# Technical Service Bulletin

## 69 Airbag warning light on, DTC B120E1B

69 23 02 2072023/1 November 15, 2023.

Model(s)	Year	VIN Range	Vehicle-Specific Equipment
Q5, Q5 e quattro, Q5 Sportback, SQ5, SQ5 Sportback	2021 – 2024	All	Not Applicable

*Figure 1. Tension on connector for airbag release valve igniter.*

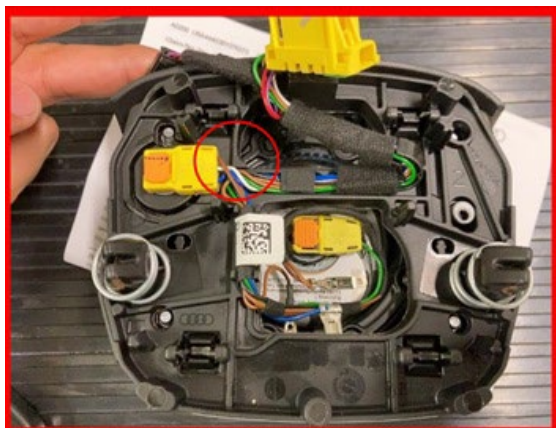
The wire routing of the driver airbag release valve igniter, N490, is not optimal causing tension on the release valve igniter connector. During vibrations, this tension leads to an increased electrical resistance.

1.	Remove the driver airbag according to: <i>Elsa&gt;&gt;Repair manual&gt;&gt;Body&gt;&gt;Body Interior&gt;&gt;69 Passenger Protection, Airbags, Seat Belts&gt;&gt;Driver Side Airbag&gt;&gt;Airbag Unit with Igniter, Removing and Installing.</i>
2.	Check the routing of the driver airbag wire harness. Pay close attention to the wire routing of the driver airbag release valve igniter, N490 (Figure 1, 2).

3. Replace the driver airbag wire harness. Route the new wire harness without causing tension on the airbag connectors.
4. After reinstalling the driver airbag, clear all fault codes.
